Access Compliance Report

Public Rights-of-Way

(Curb Ramps)

Intersection ID: 6421	Main Street: S SHOPPING CENTER DR	Cross Street: UNIVERSITY CITY BV	Location:	N
ADA ID: 5C63E49E91E1	Ramp Type: PerpDiag	Initial Pass/Fail: Fail	Overall Compliance: No	Severity Score: 37.5
Codes/Mitigation Info/Possible Solution		Field Measurements/Component Compliance

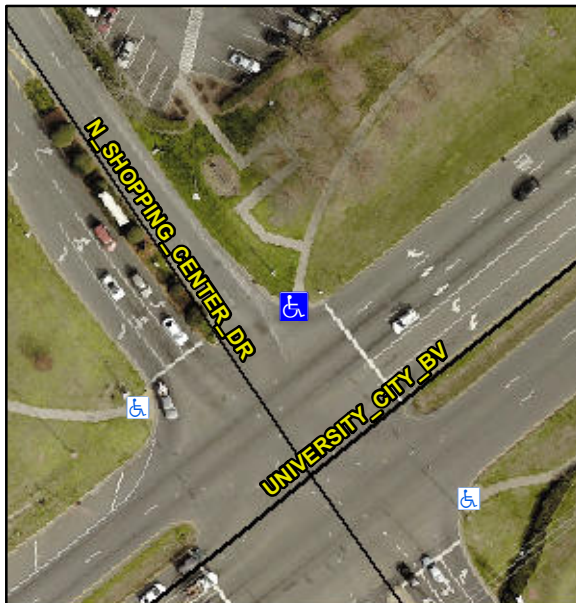
PROW/ADA:

Not Found, R304.2.2, R304.5.3

Compliance	Description	Data	Compliance	Description	Data
N/A	Ramp Length (in)	110.0	No	Ramp Slope (%)	8.6
Yes	Ramp Width (in)	58.0	No	Ramp XSlope (%)	8.6
N/A	Flare Type LT	N/A	N/A	Flare Type RT	N/A
N/A	Flare Slope LT (%)	N/A	N/A	Flare Slope RT (%)	N/A
N/A	Flare Traversable LT?	N/A	N/A	Flare Traversable RT?	N/A
N/A	Landing Length (in)	N/A	N/A	DWS Provided?	N/A
N/A	Landing Width (in)	N/A	N/A	DWS Contrast?	N/A
N/A	Landing Slope (%)	N/A	N/A	DWS Length (in)	N/A
N/A	Landing X Slope (%)	N/A	N/A	DWS Full Width?	N/A
N/A	Landing Curb? (Y/N)	N/A	N/A	DWS Offset (in)	N/A
N/A	Shared Landing?	N/A			
N/A	Gutter Ponding?	N/A	N/A	Gutter Slope (%)	N/A
N/A	Gutter Lip Ht (in)	0.5	N/A	Gutter X Slope (%)	N/A
N/A	Painted X Walk1?	No	N/A	Painted X Walk2?	No
	X Walk 1 Direction	To S		X Walk 2 Direction	To W
N/A	X Walk 1 Width (in)	N/A	N/A	X Walk 2 Width (in)	N/A
	X Walk 1 Slope (%)	1.6		X Walk 2 Slope (%)	2.9
	X Walk 1 X Slope (%)	6.0		X Walk 2 X Slope (%)	4.7

N/A	Ramp inside XWalk1?	N/A	N/A	Ramp inside XWalk2?	N/A
	Road Slope (%)	8.4	N/A	Clear Space?	N/A
	Road X Slope (%)	4.3	N/A	Clear Space to XWalk (in)	N/A
N/A	Any Obstructions?	N/A	N/A	Storm Grate/Utility Hazard?	N/A
	Obstruction Type			Storm Grate/Utility Type	
		N/A			N/A
		Yes		Surface Condition? (G/P)	Good

Possible Solutions:

Remove & Replace Curb Ramp With Two New Directional Ramps or Equivalent.
